1 Q. As noted at page 1, lines 11-13, of Hydro's Report on the Replacement of  
2 Equipment Resulting from Sunnyside T1 Transformer Failure:  
3 "On January 4, 2014 Sunnyside T1 transformer faulted, with the most probable  
4 cause being a bushing failure that initiated inside the transformer. As a result of this  
5 fault, a fire developed leading to the irreparable damage of the transformer and  
6 associated equipment."

# **DESIGN STUDY AND FAILURE INVESTIGATION FOR AUTO TRANSFORMER**

**NALCOR**

**SERIAL # 289147**

**Photo 17 – LV1 Bushing**

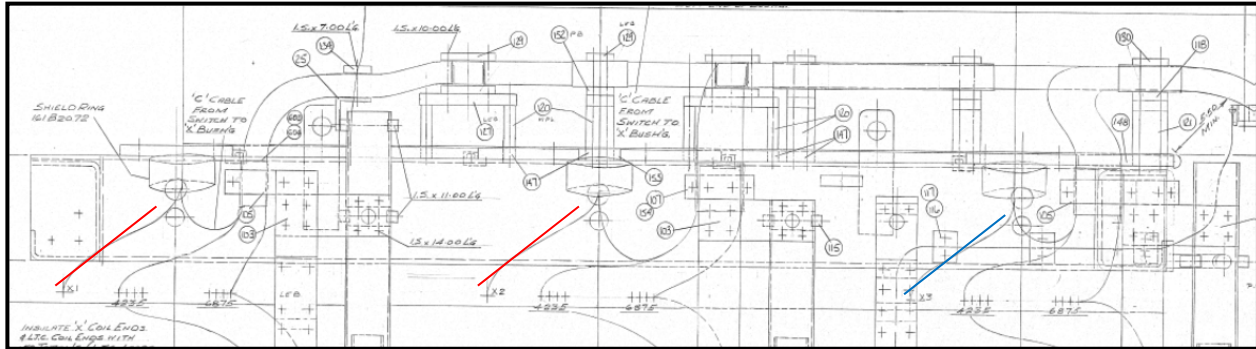
- No sign of phase to phase failure in the windings was found during the inspection.
- The L1 & L3 bushing's porcelain inside the transformer were shattered. Also marks of flashover were seen on core clamp just opposite to Phase 1 LV bushing.

Based on the internal inspection observations, all the information available and the system analysis findings, it is concluded that most probably the LV1 or LV2 bushing failed first which initiated the failure and resulting fire.
